MEMORANDUM – Internal Review Draft

RE: Staff Analysis of the Wastewater Reuse Permit Application Report for the City of Tetonia, Teton County, Wastewater Reuse Permit Application Request LA-000208-01 (Municipal Wastewater).

Figure 4. Reuse Site. (Park, 2006)

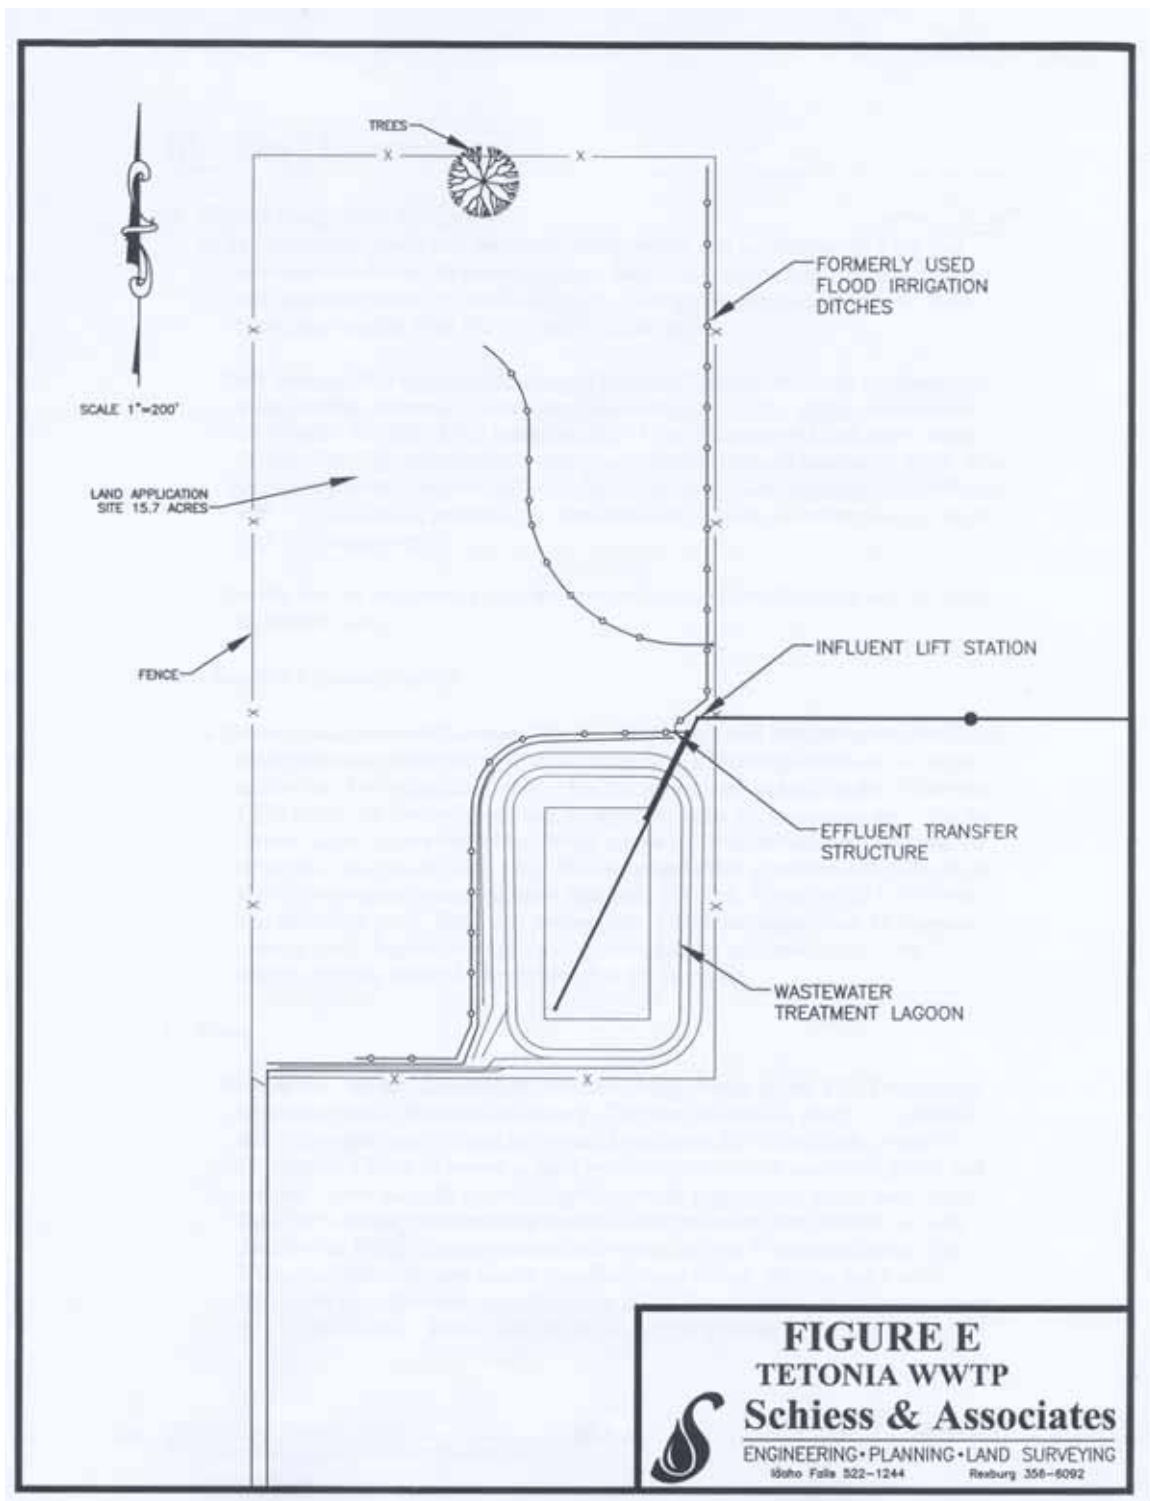
The land application (reuse) site is 15.7 acres, and is shown in Figure 4. The site was historically irrigated using flood irrigation. The soil is quite coarse and gravelly, and the site is not cropped – only weeds. The ground surface is uneven and would likely require significant work to prepare it for growing a crop. Due to the temporary nature of this permit, and the significant expense of establishing a viable crop on a temporary site, DEQ will not require any crops at this time.

The transfer structure was historically used to transfer effluent from the lagoon to the wastewater reuse site via flood irrigation. Due to the coarse soils at the site, wastewater would typically infiltrate within the main distribution ditch prior to ever reaching the individual head gates. DEQ has requested and the City has agreed to install a sprinkle irrigation system to provide more uniform coverage of the site. More uniform coverage will reduce the potential for deep percolation and ground water contamination.

Treated wastewater will be pumped out of the existing concrete transfer structure using a 30hp centrifugal pump capable of 400 gpm at 85 psi. Wastewater will be carried to two (2) big guns mounted on portable cart assemblies using standard 4-inch aluminum irrigation pipe. The cart assemblies will allow the guns to be manually relocated on a regular basis. The guns will cover 1.8 acres each (3.6 acres total). The operator will move each end gun at the end of each week, covering the entire 15.7 acre site once per month.
